AGENDA PORTLAND PLANNING BOARD MEETING

To: Chair Mazer & Members of the Planning Board
From: Jimmy Dealaman, Planner
Date: March 5, 2021
Re: Presumpscot Elementary School Addition & Renovations Project
Project ID: PL-001297-2020, CU-001329-2020
Meeting Date: March 9, 2021
CBL: 425 A007, 428 F013, 427 1001

Portland Public Schools has applied for a Conditional Use and a Level III Site Plan approval to facilitate the development of two new building additions, totaling 17,910 square feet, to the existing Presumpscot Elementary School located at 69 Presumpscot Street in the East Deering neighborhood.

SITE LAYOUT PLAN

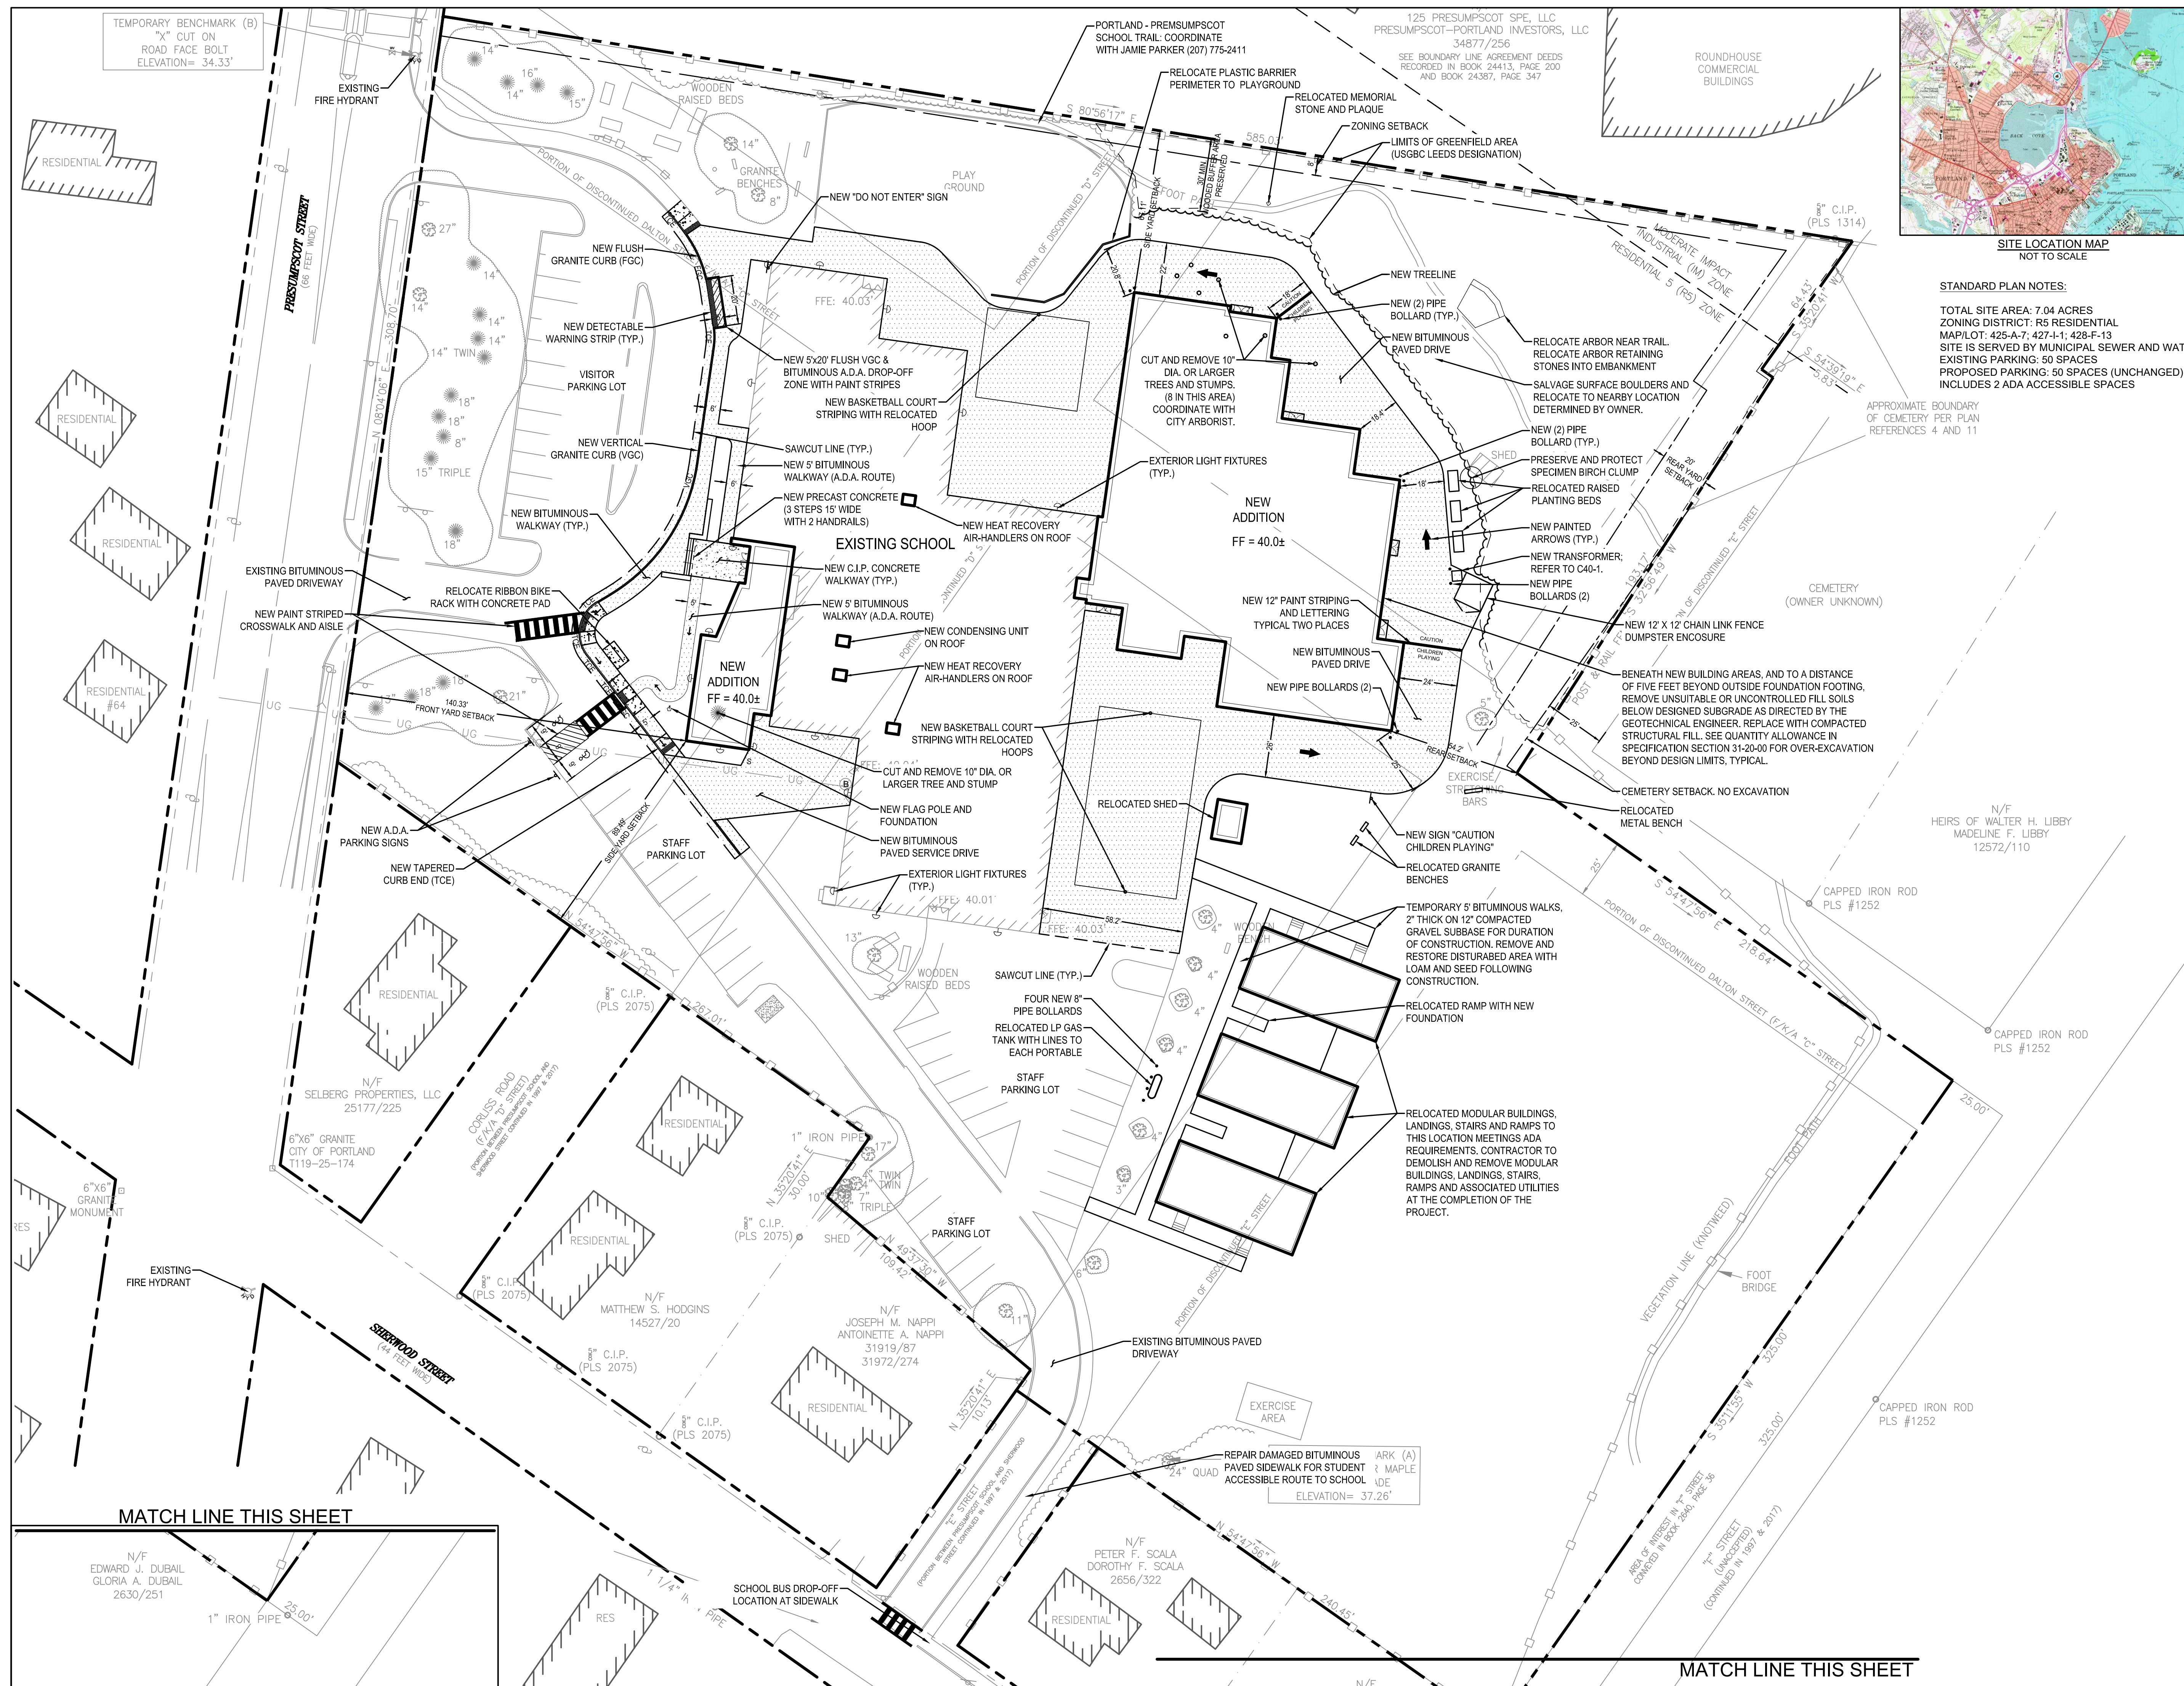
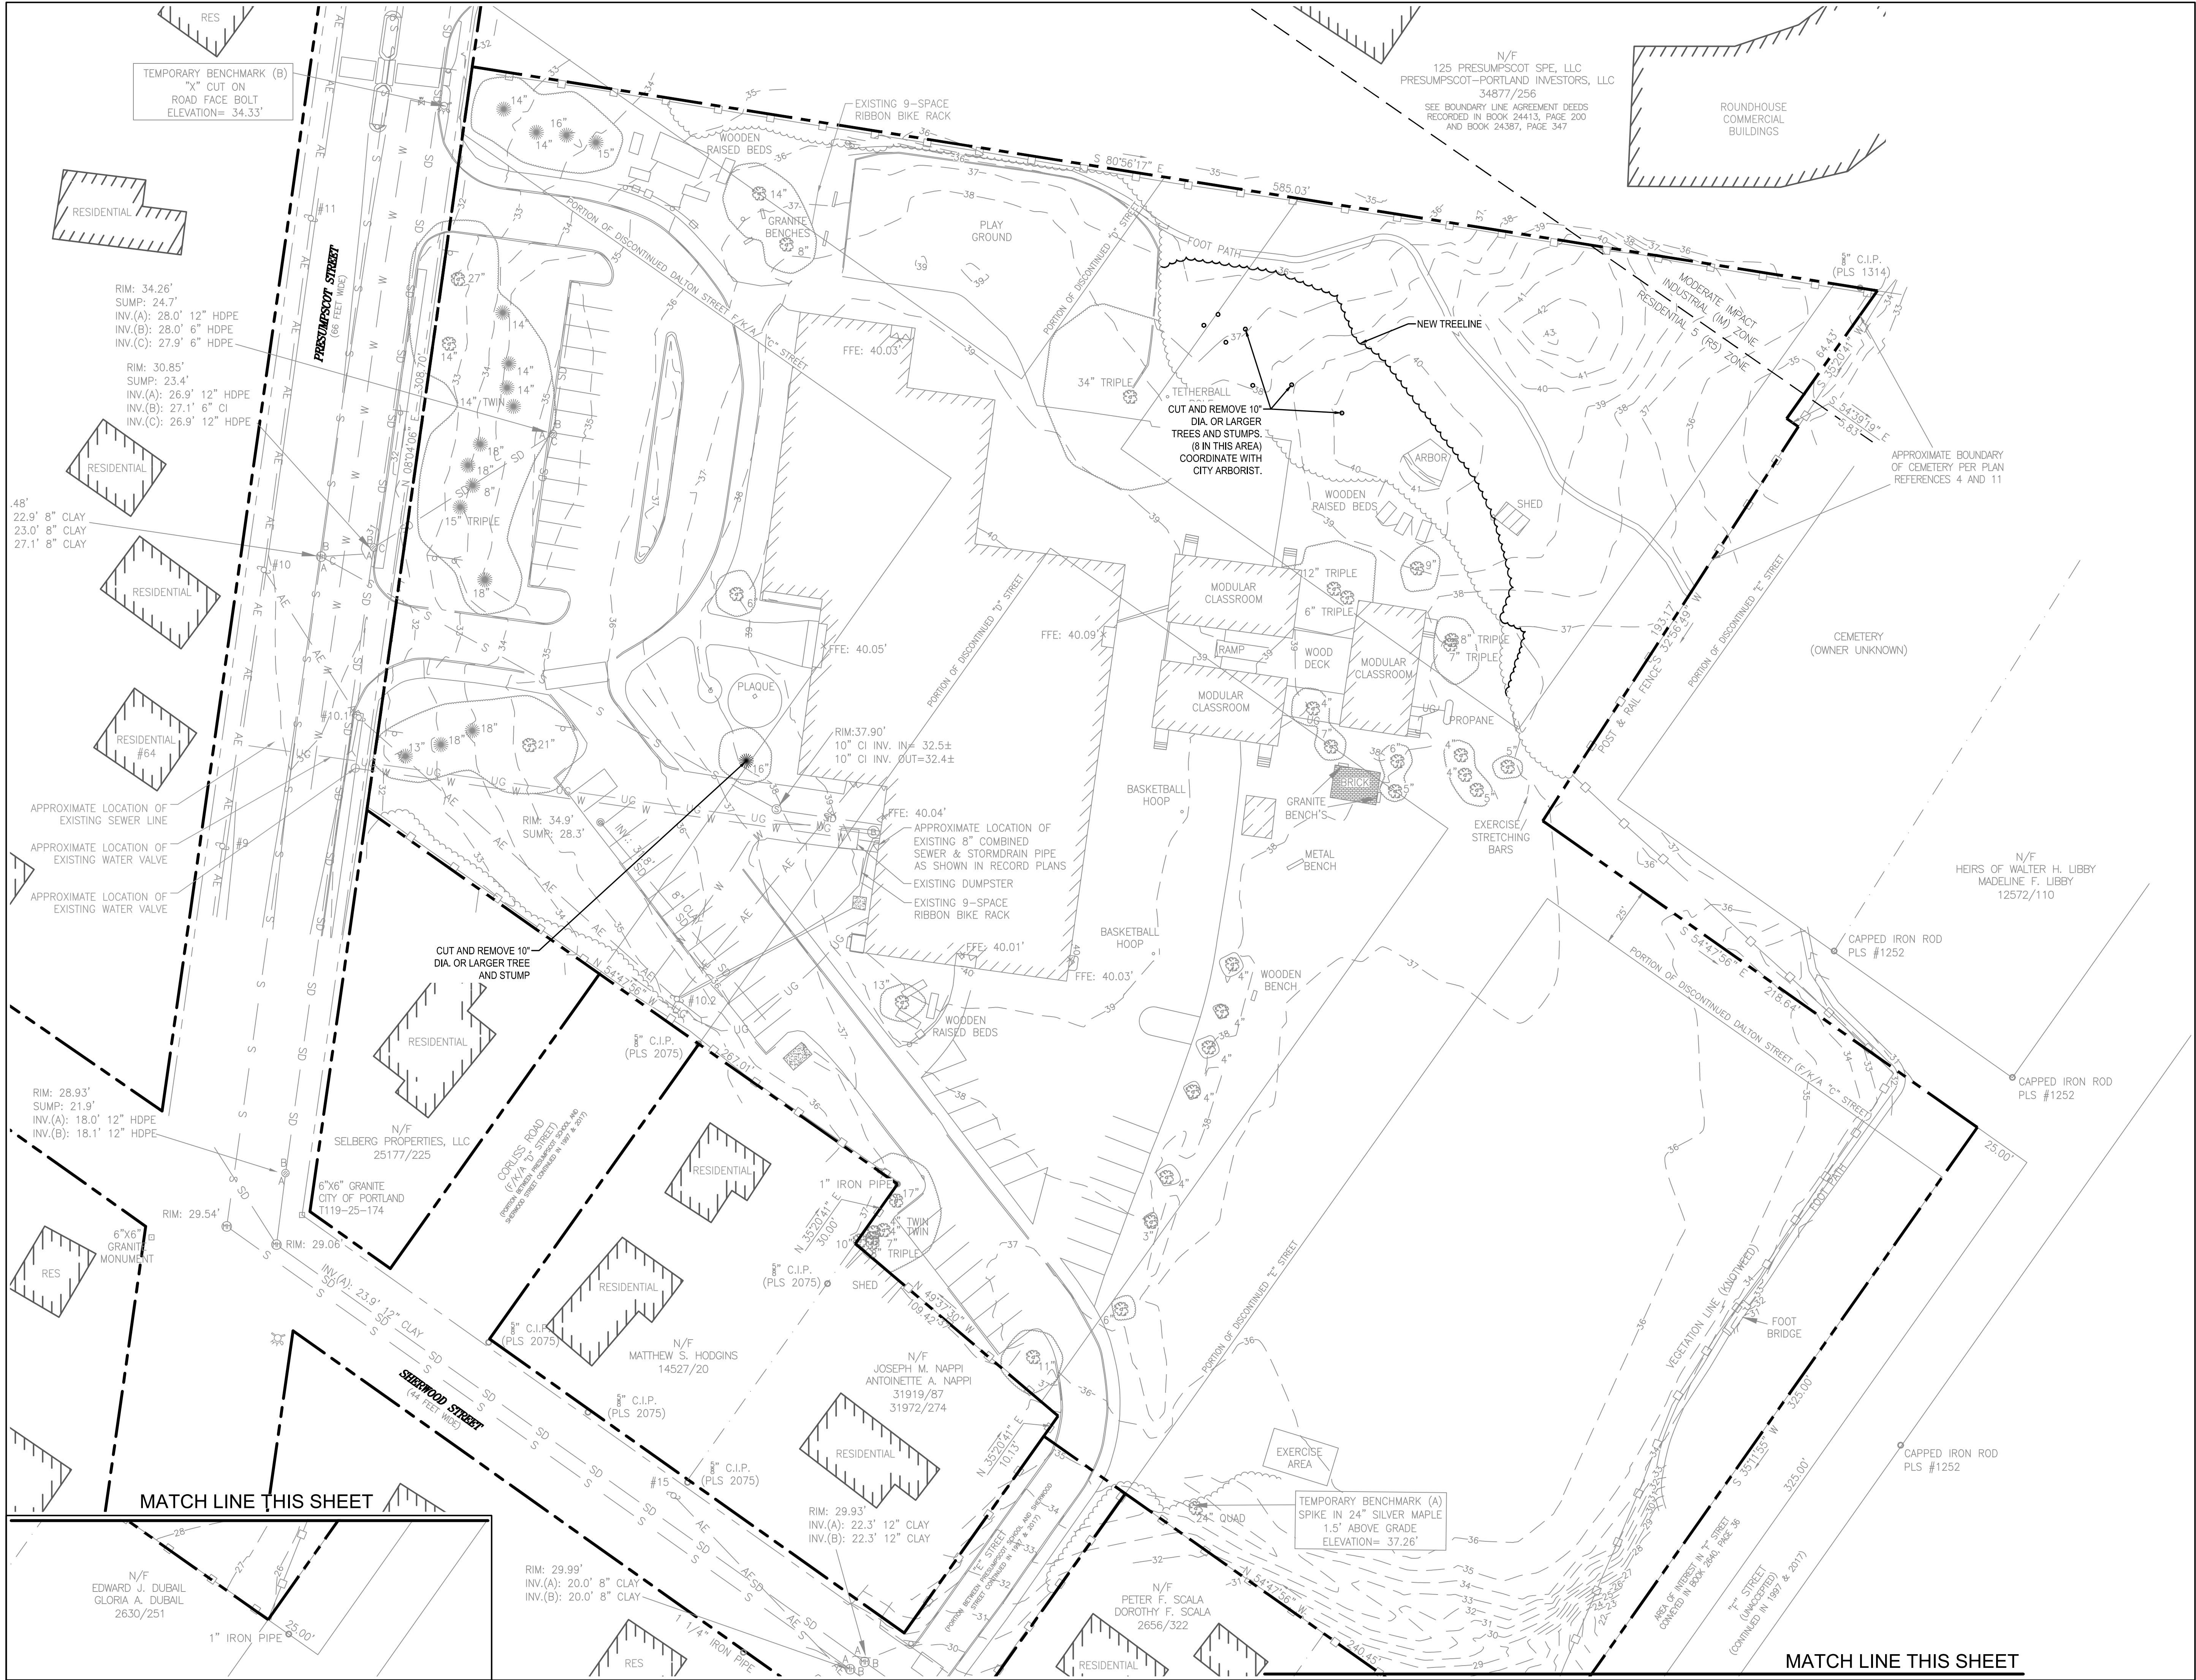
1. Distances from the new building additions to the front, rear, and both side property lines have been added to drawing C00-1 Site Layout Plan.
2. The intersection of Presumpscot Street and Sherwood Street has been completed on drawing C00-1 Site Layout Plan.

3. Corliss Road and E Street are both shown on drawing C00-1 Site Layout Plan, but I am not sure where 'Shaw Road' is located. The three school driveway entrances have also been noted.

6. The existing fire hydrants located on Presumpscot Street are shown on drawing C00-1 Site Layout Plan.

15. The Portland Presumpscot School Trail starts at the northern playground and runs through the wooded area to the Cemetery site. A note has been placed on drawing C00-1 Site Layout Plan to coordinate with the Portland Trails representative.

16. The setback lines have been shown on drawing C00-1 Site Layout Plan.
17. On the rare occasion that it is deemed necessary, the School Department will hire a roofing contractor to carefully shovel or scoop the snow from the roof to the ground in designated areas. Then the hired snow removal contractor will remove the snow from the site, using a bucket-loader and dump trucks.

23. The additional Conditional Use standards of 14-118 have been added to the attached Revised Conditional Use Standards exhibit #24.
24. A list of existing and proposed parking spaces has been added to the drawing C00-1 Site Layout Plan, along with notations for staff parking areas.
